VALUE ENGINEERING STUDY

Project # STP00-1004-00(002) PI No. 631260-

EXTENSION OF SR 382 FROM CR 239 TO SR 5/515 Gilmer County, Georgia

17 November 2011

PROPOSAL NUMBER: EW-1.0

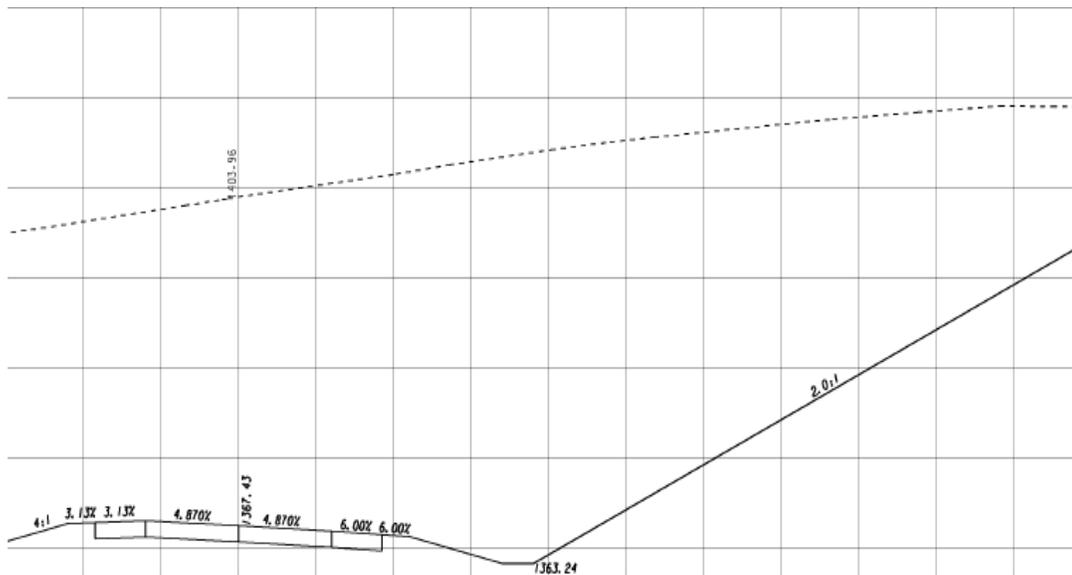
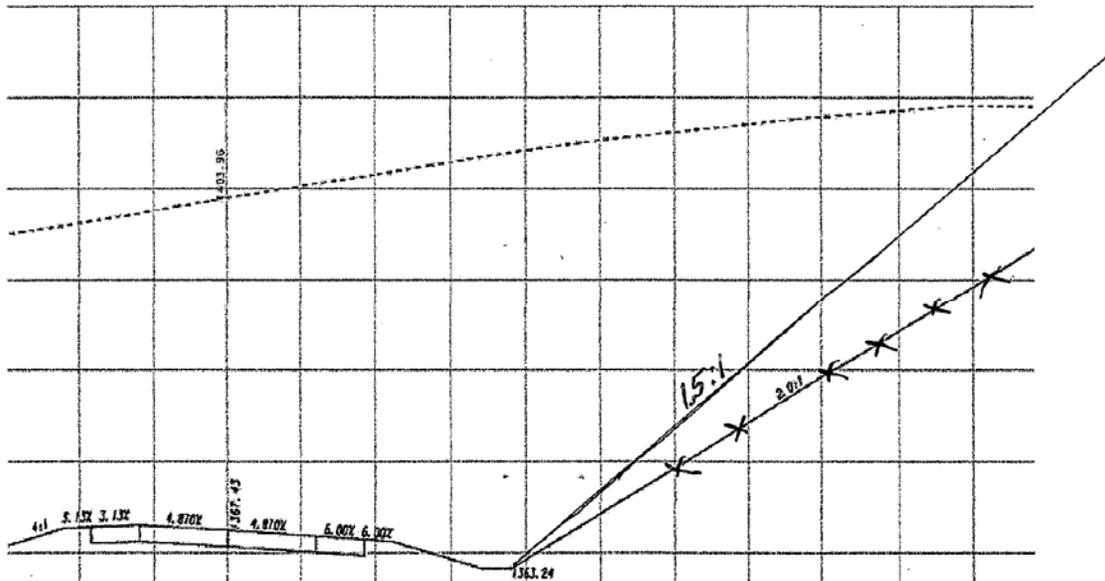
PROPOSAL DESCRIPTION:	USE GEOGRID FROM STATION 547 TO 549+50 TO INCREASE SLOPES FROM 2:1 UP TO 1.5:1 REQUIRING LESS EMBANKMENT AND ROW.
------------------------------	---

ORIGINAL DESIGN: The current design for the new extension of SR 382 to SR 515 has designed the slopes at a 2:1 ratio.

PROPOSED CHANGE: The proposed recommendation is to increase the slopes from 2:1 to 1.5:1 thus requiring less embankment and less ROW.

JUSTIFICATION: The use of steeper slopes in mountainous areas of 1.5:1 reduces the quantity of cut and fill; and ROW cost.

Use of 2:1 slopes in high fill areas Station 547+00 to Station 549+50 without GEOGRID

Use 1.5:1 slopes w/GEOGRID fabric Station 547+00 to Station 549+50

EW-2.0 - PROPOSED PROFILE
1 OF 2

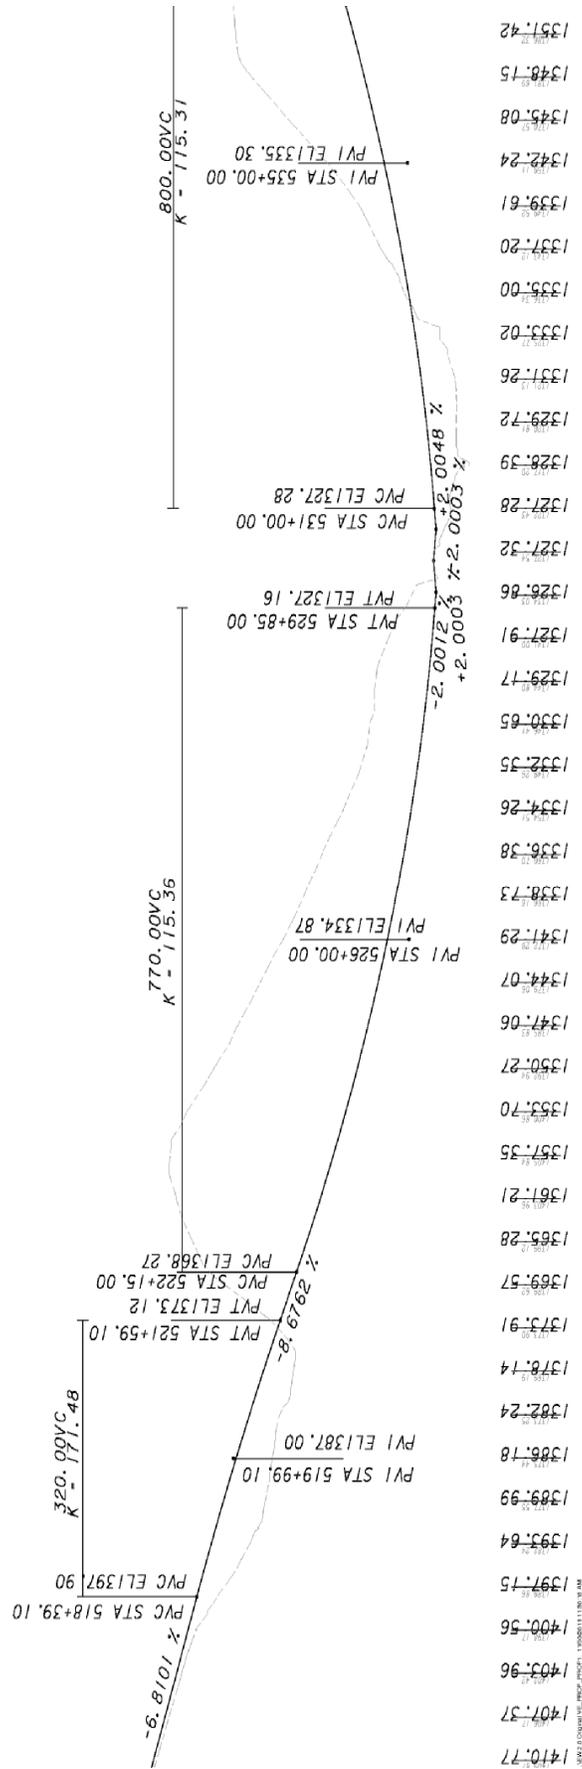
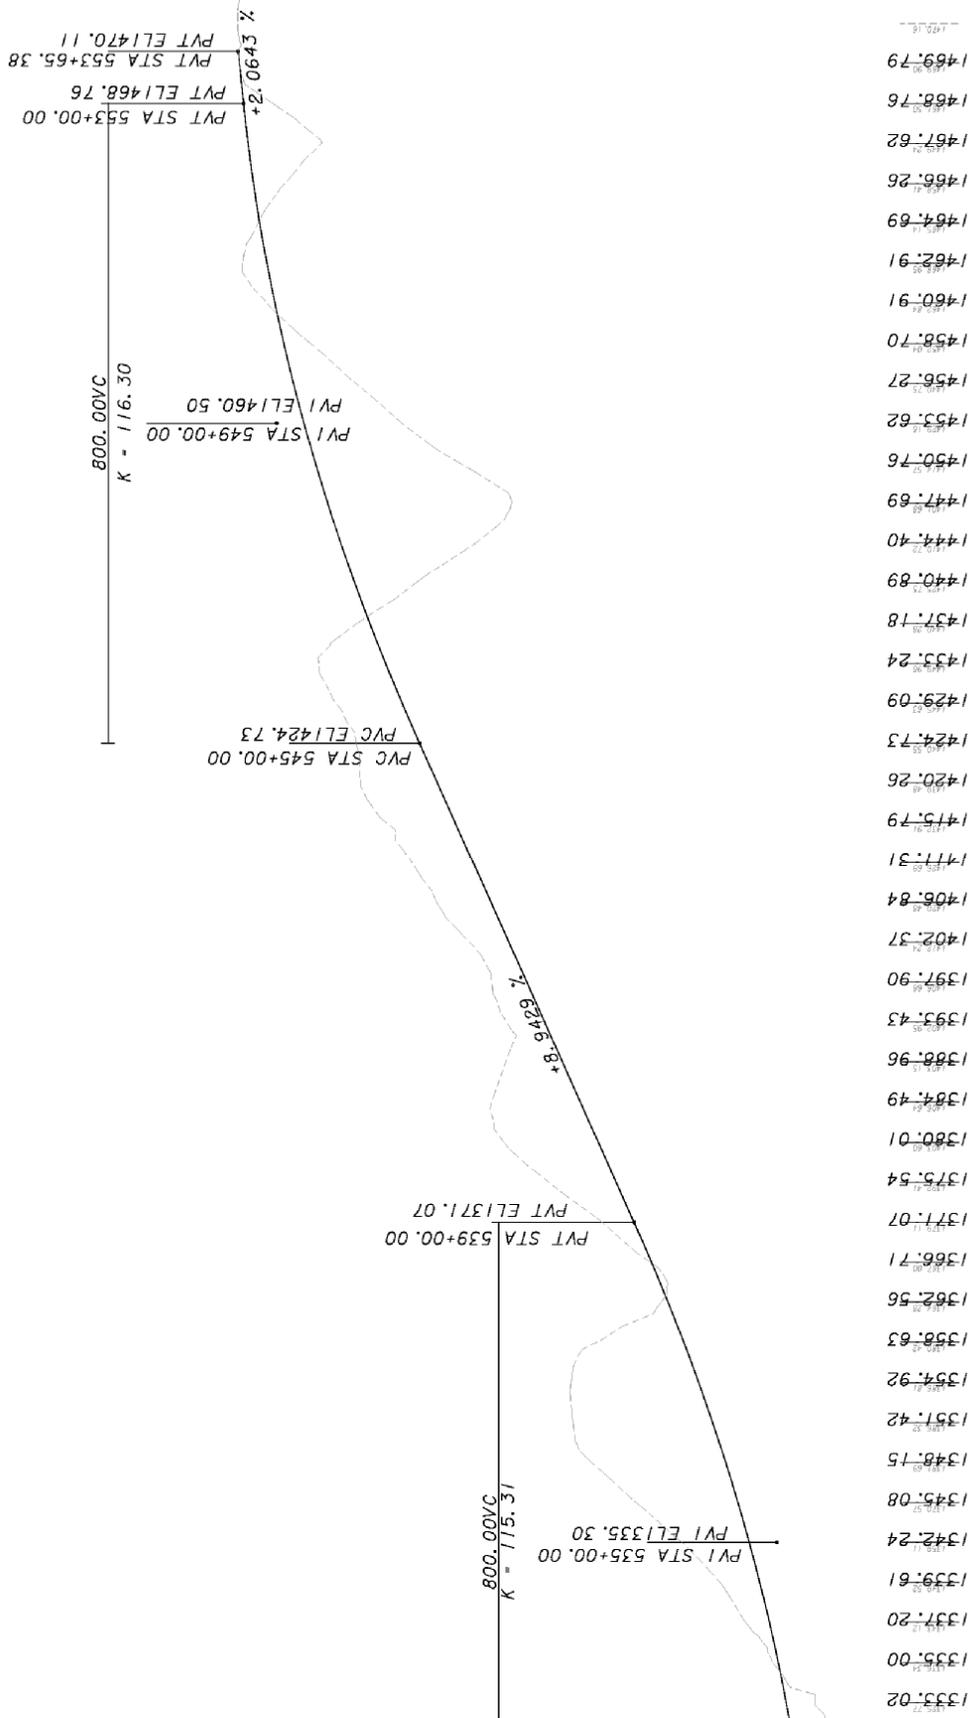
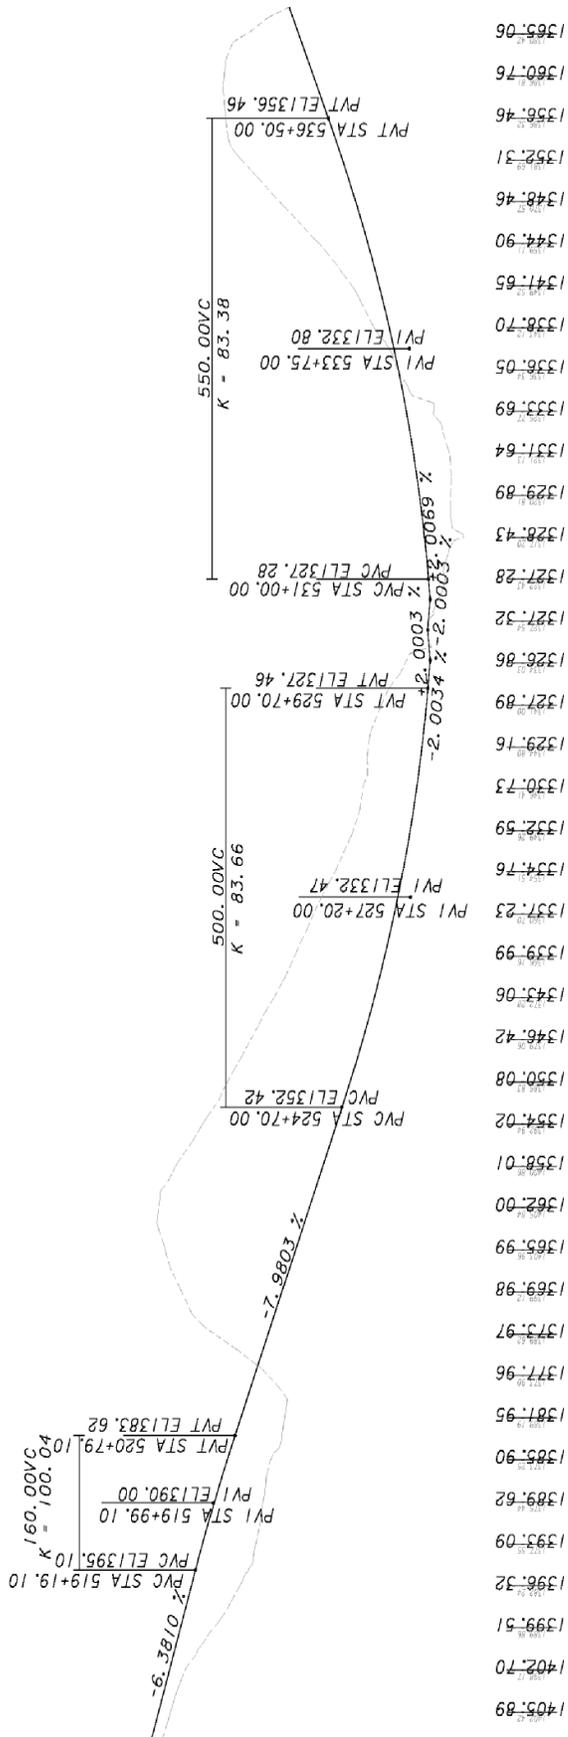
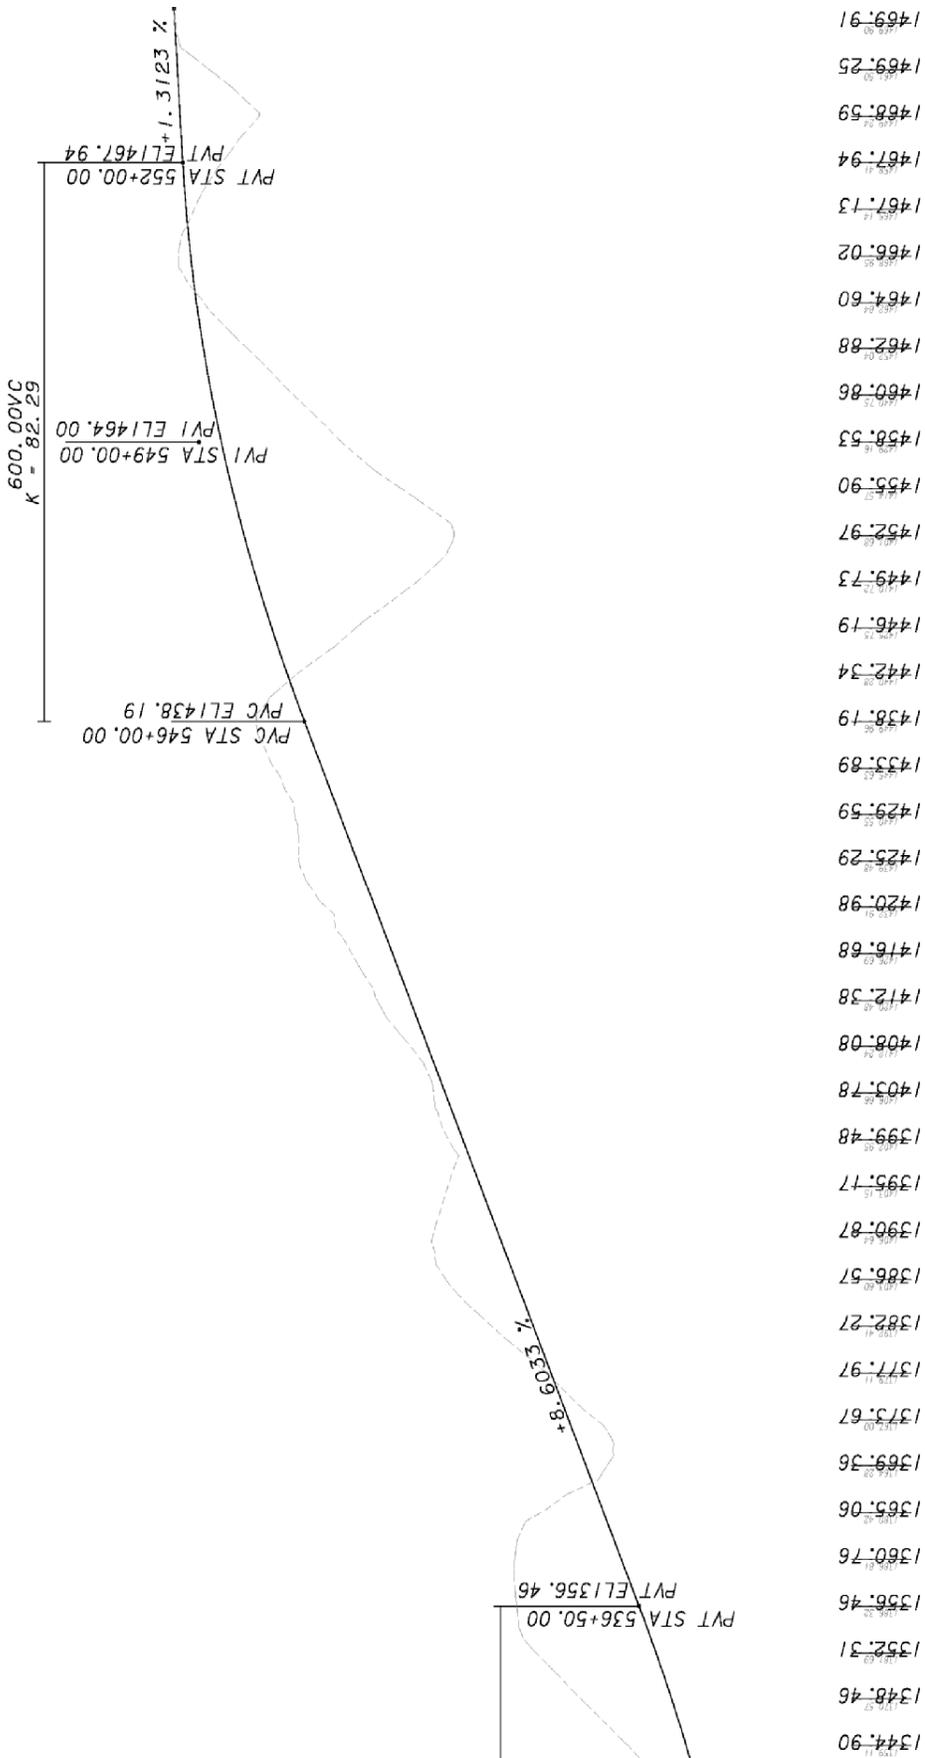
PROPOSAL DESCRIPTION: REVISE SR 382 PROFILE TO REDUCE EARTHWORK AND ROW IMPACTS ON WEST SIDE OF CR 239.

ORIGINAL DESIGN: The original design proposes a roadway profile that results in significant earthwork and right-of-way impacts on SR 382 on the west side of CR 239.

PROPOSED CHANGE: The proposed change proposes a SR 382 roadway profile that reduces the quantity of required earthwork and the amount of right-of-way impacts on the west side of CR 239. The cross slope of CR 239/SR 382 will be changed from normal crown to reverse crown at the intersection to facilitate the profile adjustment.

JUSTIFICATION: The original design proposes a profile that produces significant excavation on SR 382 on the west side of CR 239 because of the tie-in at CR 239. The maximum allowable breakover for a side street at an intersection is 4%. Although the standard cross slope for a roadway with a tangent alignment is normal crown, a reverse crown cross slope may be implemented. This change in cross slope allows the profile to be raised and reduces required excavation.
